Land Between Lodge Road and Tape Lane, Hurst, Wokingham, RG10 0EG

Supplemental Proof of Evidence – Flood Risk and Drainage (Floodplain Compensation Storage) [CD9.15]

Section 78 Appeal against refusal of planning permission by Wokingham Borough Council for the:

PINS Reference: APP/X0360/W/25/3364304

Drawing Title
SOUTHERN COMPENSATION SCHEME

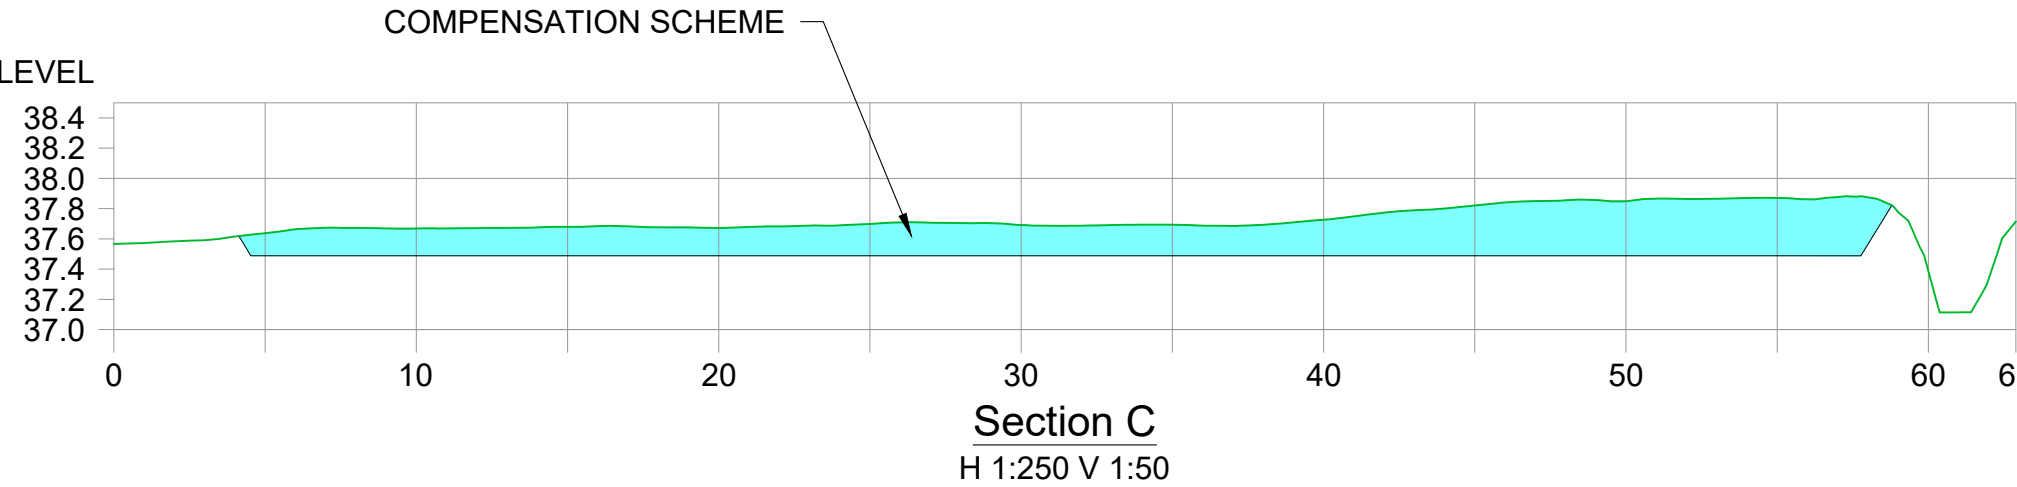
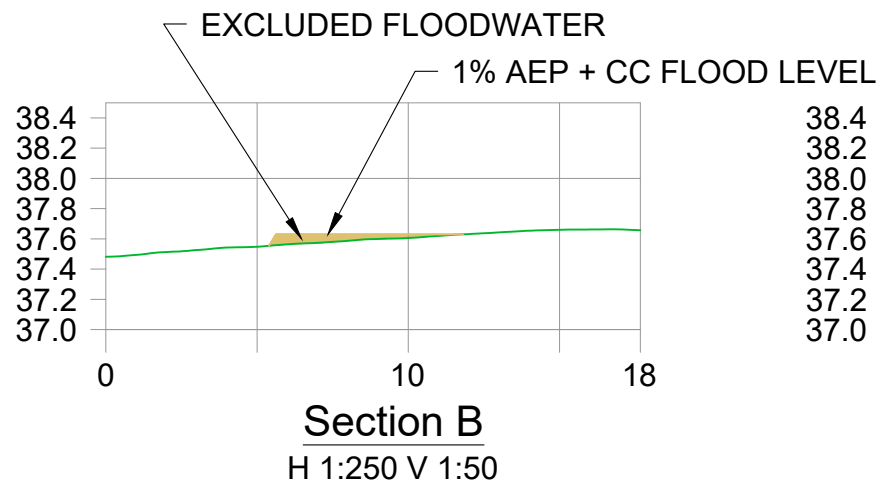
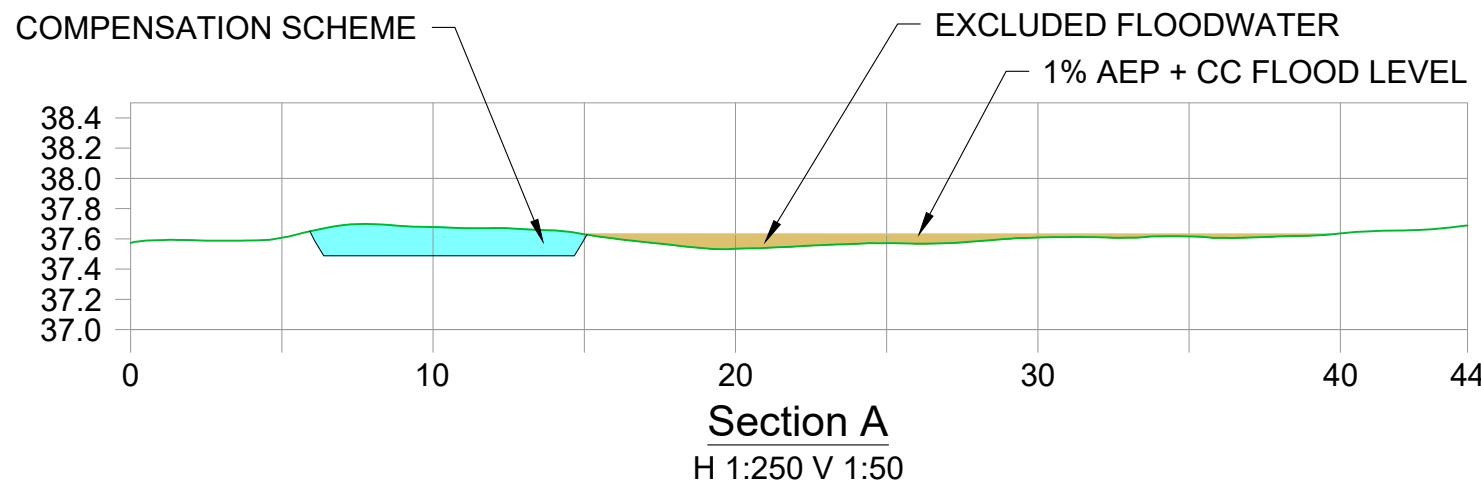
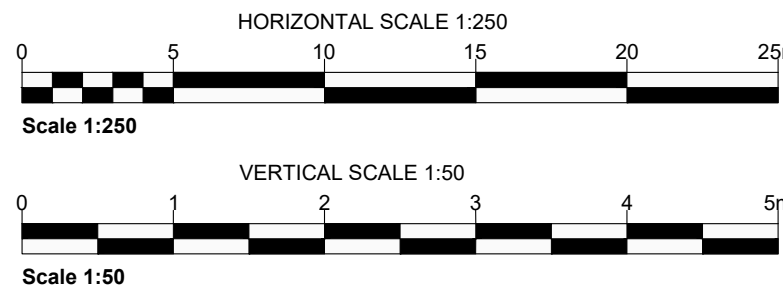
The submitted FRA dated August 2025 by SLR consulting Ltd does not comply with the requirements for site-specific flood risk assessments, as set out in paragraphs 20 to 21 of the Flood Risk and Coastal Change Planning Practice Guidance and its site-specific flood risk assessment checklist. The FRA does not therefore adequately assess whether the development will increase flood risk elsewhere. In particular, the FRA fails to:

- demonstrate that any loss of floodplain storage within the 1% AEP plus an appropriate allowance for climate change can be directly compensated for to prevent an increase in flood risk elsewhere.

- 2.5 The analysis has assumed nominal 1 in 3 slide slopes to any areas of fill excluding floodwaters and cut providing compensation storage.
- 2.6 Drawing No. COMP_001 shows the two areas (shaded in a tan colour) where floodwaters would be excluded, Area 1 and Area 2, from the 1% + CC flood envelope along the western edge of the southern development area. The area shaded in cyan provides an indication of the likely area that would have to be lowered to compensate for the exclusion of floodwaters from Area 1 and Area 2.

- 2.7 This indicative compensation area is hydraulically connected to Area 1 and Area 2.
- 2.8 Following the advice set out in the Environment Agency's letter, the volume of floodwater excluded for each 0.05m deep 'slice' has been compared with that provided by the indicative compensation storage area. This is summarised in Table 2-1.

- 2.9 Positive volumes in Table 2-1 represent a loss of floodplain storage and negative volumes a gain in floodplain storage arising from the compensation earthworks. As the 'balance' is negative for each of the 0.05m 'slices', adequate compensation storage has been provided.

- 2.10 Sections A, B and C on Drawing No. COMP_001 show sections through the indicative compensation area. It should be noted that these sections are drawn with a vertical exaggeration of 5 to aid clarity.
